PROJECT NAME: ORANGE BLOSSOM REPLAT #2  
PROJECT NUMBER: 2025050014  
APPLICATION: PRELIMINARY PLAT #32813

# AR #32813

## DEVELOPMENT REVIEW PLAN APPLICATION

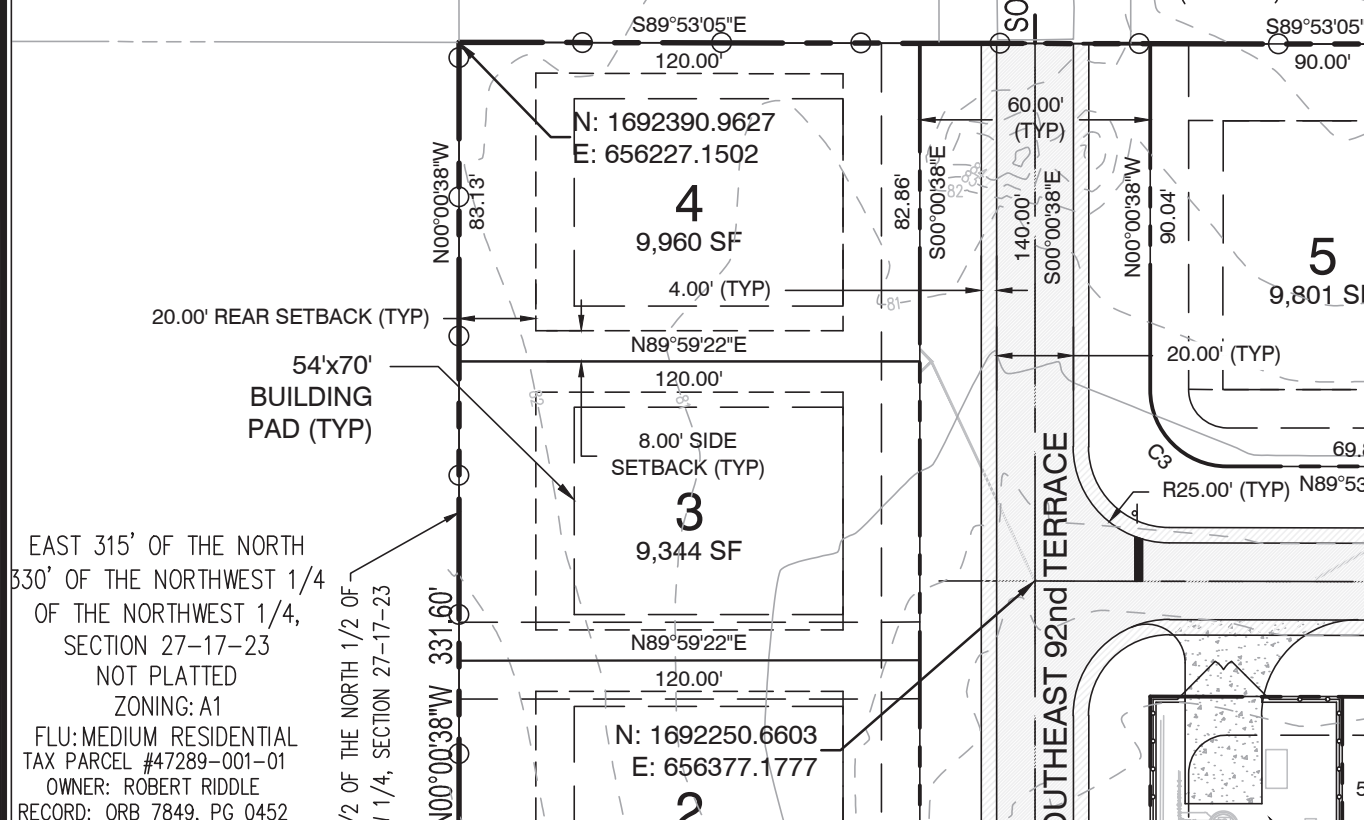
REMARKS: 7/22 review: For properties in Orange Blossom Unit 15 that are in adjacent to the subject property, the zoning is R-4, not A-1. Please correct.
